## Firmware 2.06.3 bug list:

## List of bugs/improvement requests

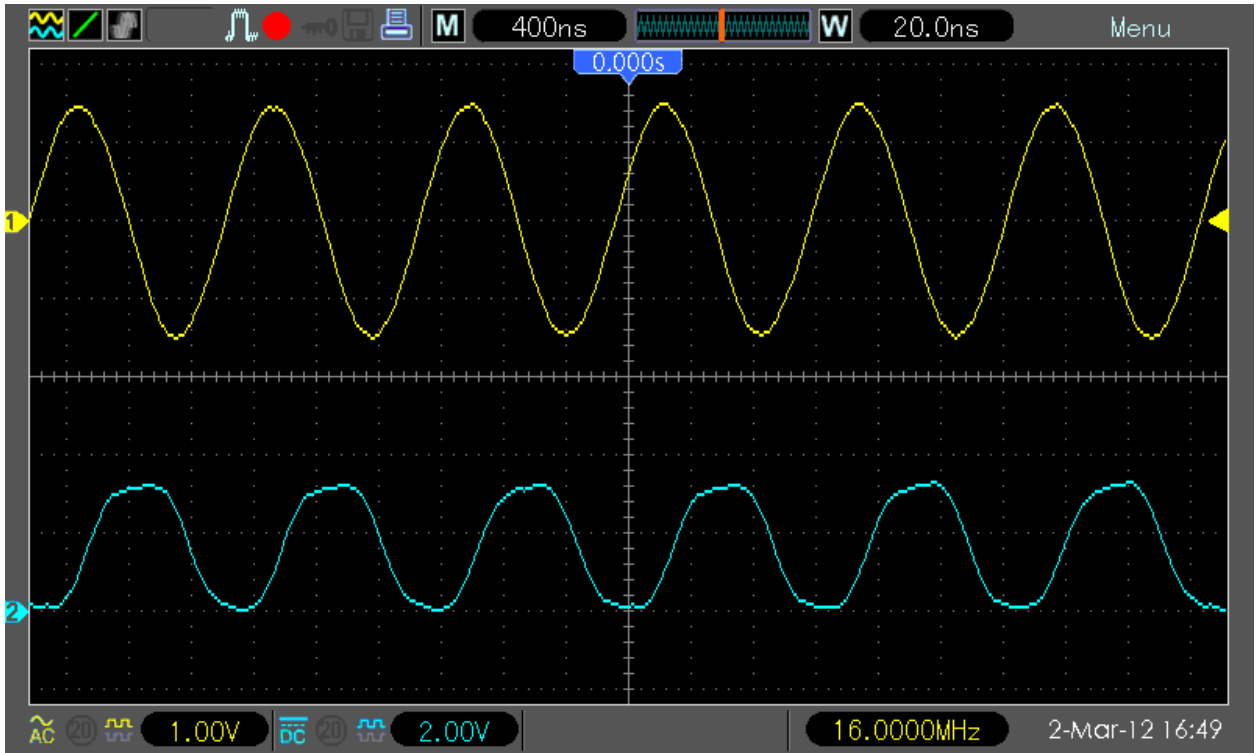
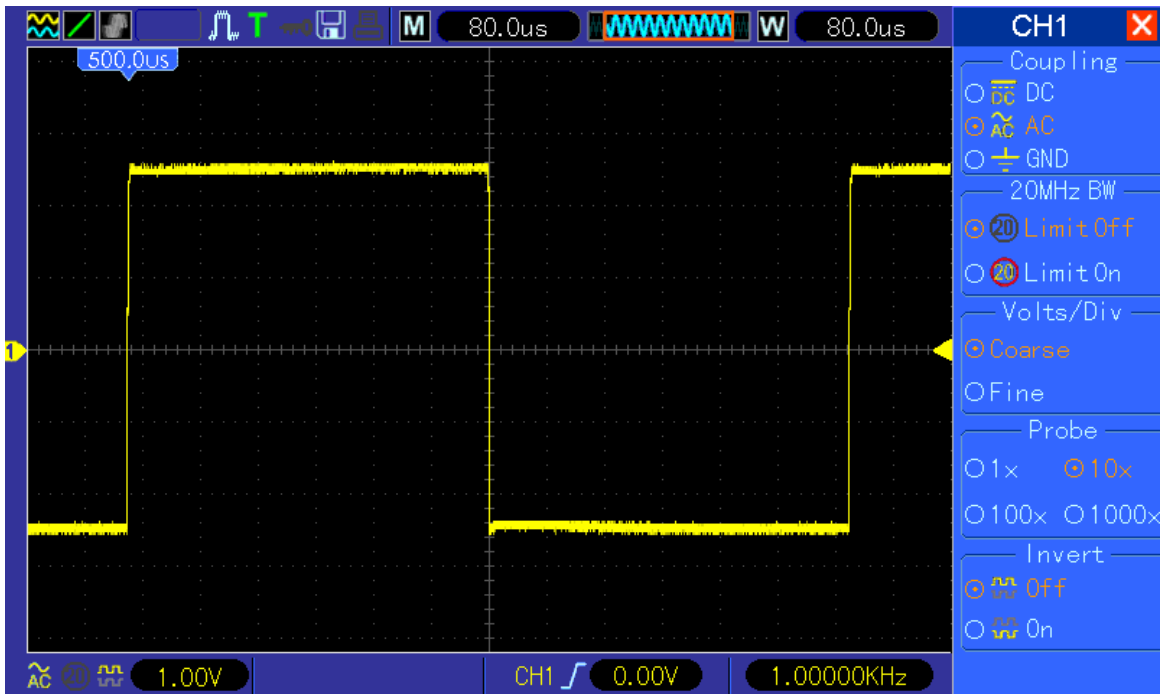
14. Dithering/interpolation filter of waveform too sharp. When enabling both channels (this also occurs in single channel mode and 1GSs, but test signal need to be higher to get same error) and applying for example 16MHz square wave the waveform is switching between proper square:

and crippled square every second:

14. For sure a stupid bug, but since you can see when the signal is “wobbling” you can quick change (when necessary) to single channel to observe the waveform with better resolution and without wobble.
15. Funny bug, but easy to omit since we know it (remember, with higher sample depth there is no issues)
16. This is already fixed, the /dsod (or /dso/app/dsod — this depends on fw/DSO model version) binary is working perfectly as watch dog monitoring potential profile issues.

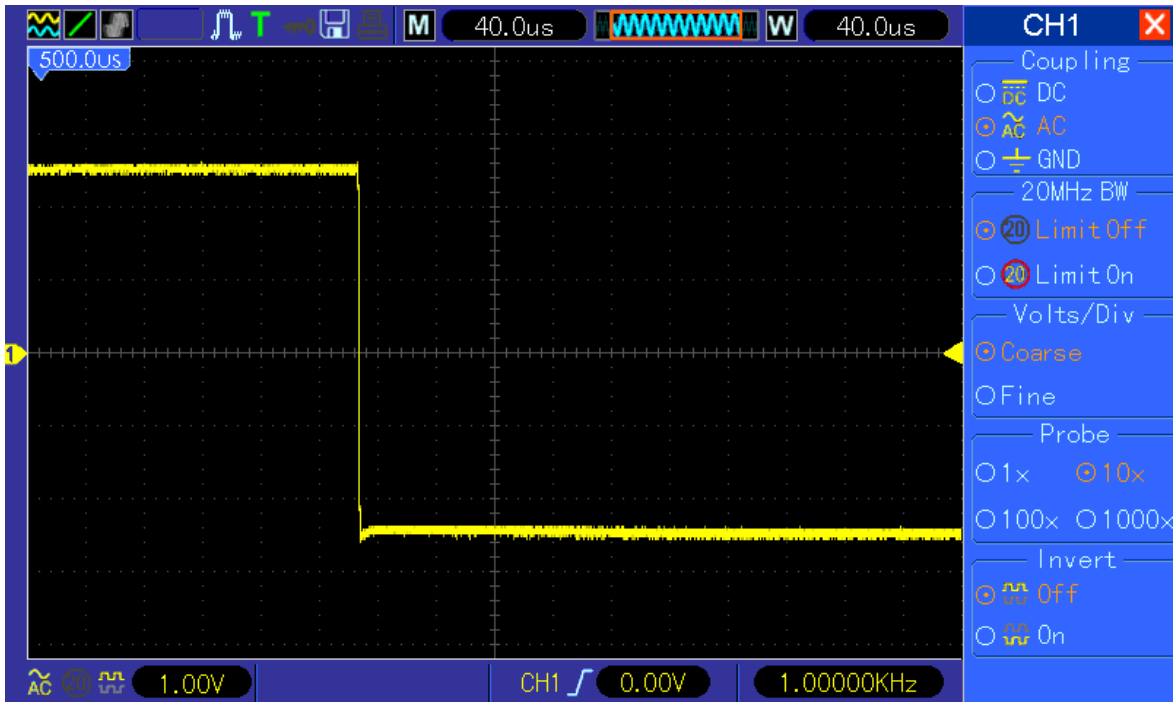
15. Display / Time base scaling strange behavior. When you apply e.g. 1kHz signal, set time base to 80us/DIV and move the waveform to 500us/DIV (bug only in 4/40k memory depth, 512k/1M/2M works fine):

When you now change time base to 40uS/DIV the falling edge (which should be still in the middle of the screen) has been moved to 454uS position (but it should stay on 500uS). The same happens of course with 20uS/DIV.

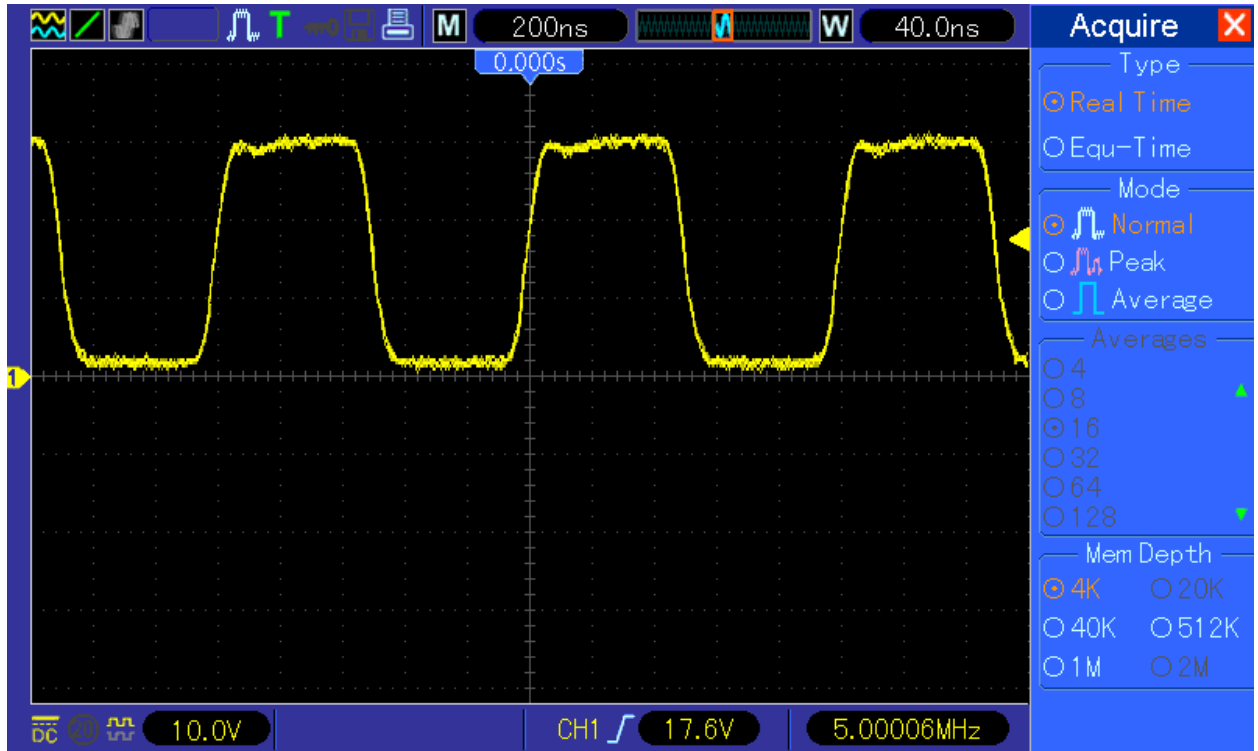
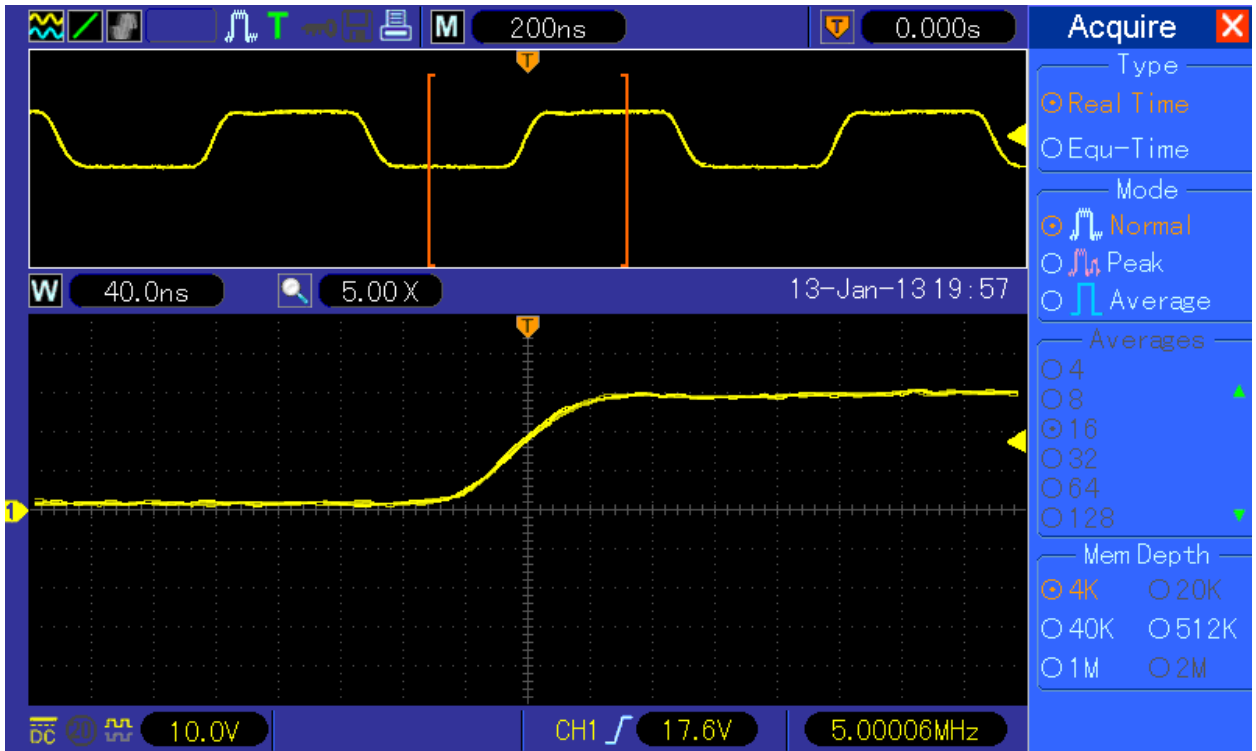
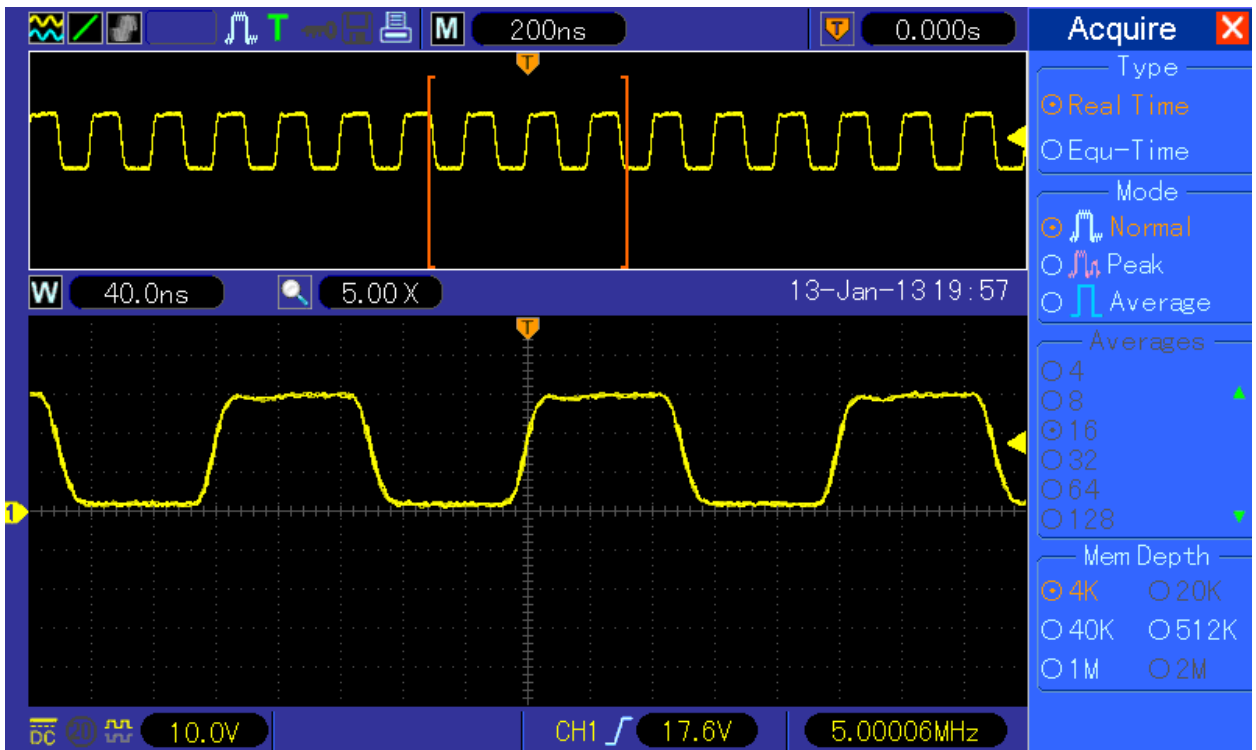
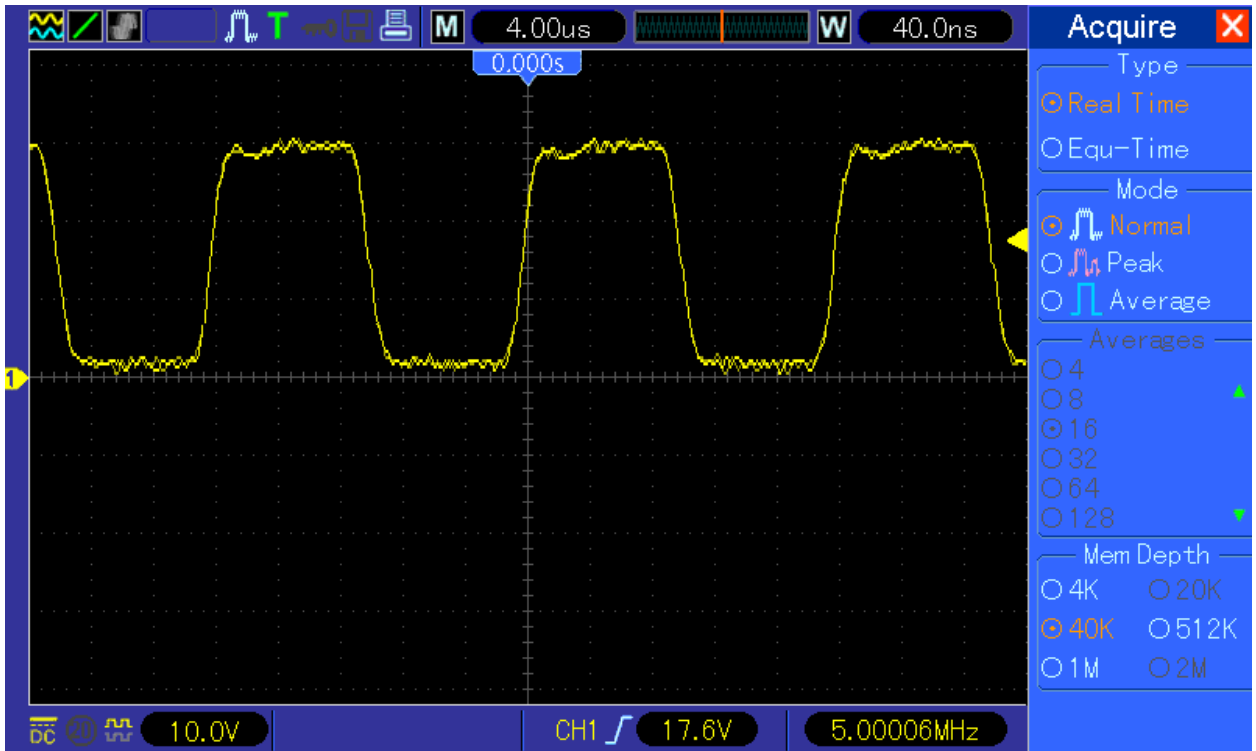
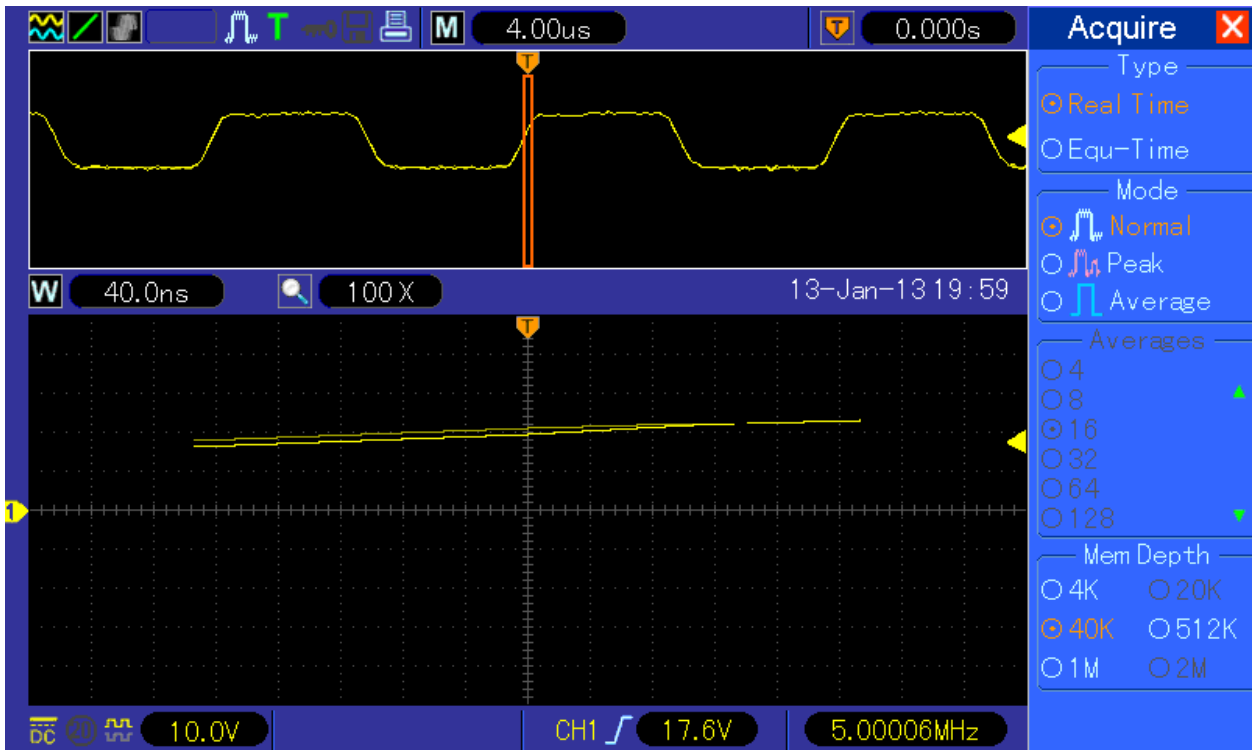
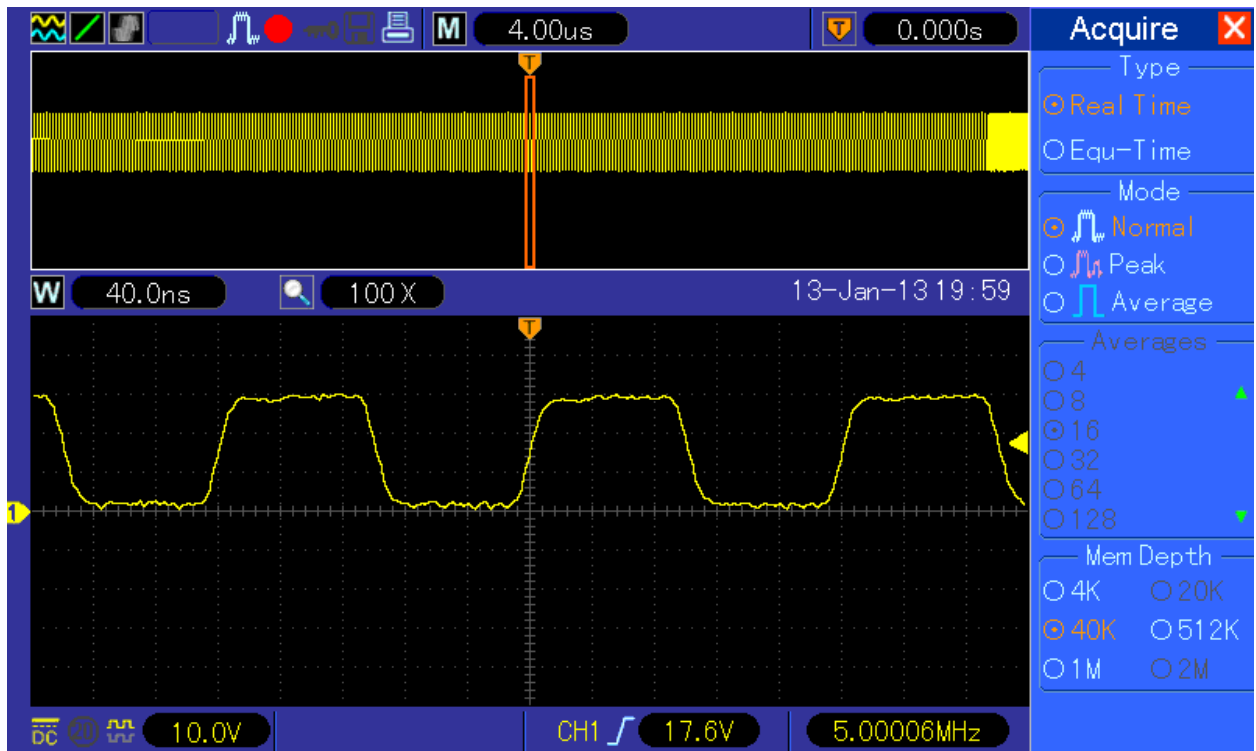
26. While switching to Dual Window (F7) , if  $WTB < MTB$ , the MTB displayed value is not always set properly. **Up to fw 120423.0 it was working properly, in 120808.0 and 121027.0 the MTB scale changed in a completely wrong way (see bug 27), in fw 121208.3 following behavior:**

This seems to be only issue when  $MTB < WTB$ , with  $MTB=WTB$  it does works properly.

Example1: 4k depth, 5MHz signal, 40ns/DIV WTB

now when we change with F7 to dual window the top window is showing wrong scaled waveform, the resulting bottom zoom window showing as well wrong :

when we turn now the Timebase knob one position “up” (200ns/DIV is actually to max “up” position for MTB by 4k depth, but by turning the knob firmware is updating windows) the waveform in top and bottom window is properly scaled:

Example2 : 40k depth, 5MHz signal, 40ns/DIV WTB

now when we change with F7 to dual window the top window is showing wrong scaled waveform, the resulting bottom zoom window showing as well wrong :

when we turn now the Timebase knob one position "up" (4us/DIV is actually to max "up" position for MTB by 40k depth, but by turning the knob firmware is updating windows) the

waveform in top and bottom window is properly scaled:

26. ~~Just ignore it for now; it is interim fw version — for testing only.~~ This is no in production firmware as well, very annoying bug.
27. Switch once focus from minor (bottom window) to major (top window) window by pushing timebase knob down, turn then timebase one position fort and back to get rid of waveform artifacts on left and right side of the waveform.
